**BEFORE INDEPENDENT HEARING COMMISSIONERS APPOINTED BY THE
WAIMAKARIRI DISTRICT COUNCIL**

**SUPPLEMENTARY EVIDENCE OF TONY DOUGLAS MILNE
IN RESPONSE TO OFFICER REPORT
ON BEHALF OF BELLGROVE RANGIORA LIMITED
REGARDING HEARING STREAM 12E**

DATED: 2 August 2024

Figure 2: Bellgrove Amended Revised SER-ODP including clarification of the eastern boundary 20m green buffer width minimum (referred to as the **‘Updated SER-ODP’** in the SE of Michelle Ruske-Anderson dated 2 August 2024).

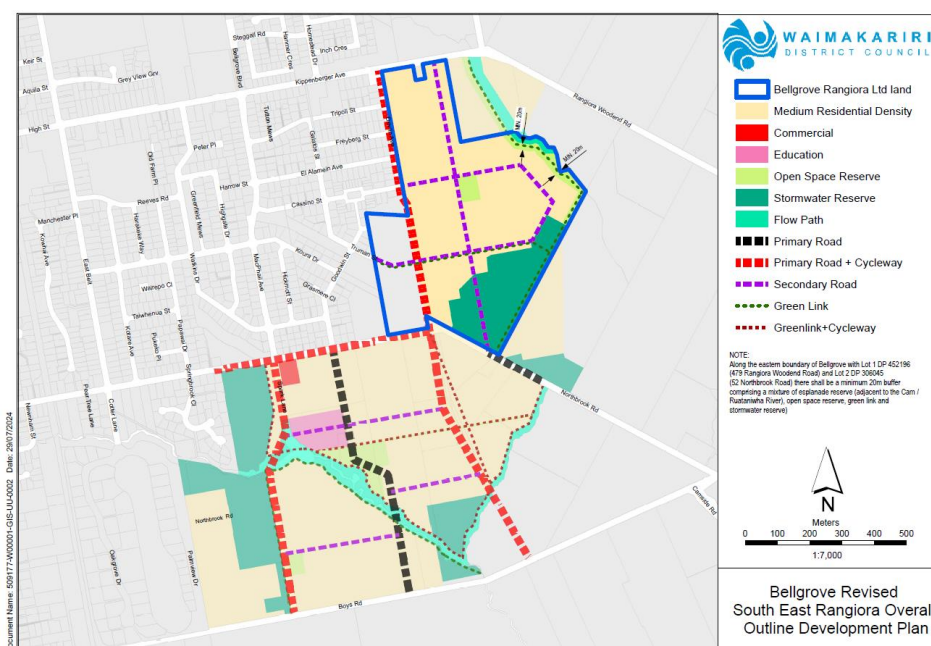
15 Having reviewed these recommendations, I am of the opinion that the open space approach as shown on the Amended Revised SER-ODP is preferable in comparison to Mr Jolly’s recommendations. Refer to Figure 2 below which is the Updated SER-ODP (*the Amended Revised SER-ODP updated with the dimensions of the open space strip now shown along with narrative text as discussed in paragraph 20 below*).

- 20 I note that while Mr Jolly has recommended a 40m buffer to both sides of the Cam/Ruataniwha River (*refer Figure 1 above*), the Officer Report at [605] recommends *"At least a 20m open space strip between any urban development on Bellgrove South and their property boundary, irrespective of a relationship with the Cam"*.

- 21 I can confirm that the 20m open space strip as shown on the Updated SER-ODP is at least 20m in width. Given this, there is no need to update, by way of increasing the width of the open space strip, the Revised SER-ODP to reflect this. However, I draw the Commissioners attention to Figure 2 above which is the Updated SER-ODP with the dimensions of the open space strip now shown along with narrative text. For ease of reference, I have included the Updated SER-ODP in Attachment 1.

- 22 The narrative text with a '20m minimum wide' notation has been added to clarify that along the eastern boundary of Bellgrove South with Lot 1 DP 452196 (479 Rangiora Woodend Road) and Lot 2 DP 306045 (52 Northbrook Road) there shall be a minimum 20m buffer comprising a mixture of esplanade reserve (adjacent to the Cam / Ruataniwha River), open space reserve, green link and stormwater reserve. In my opinion this clarifies this matter.
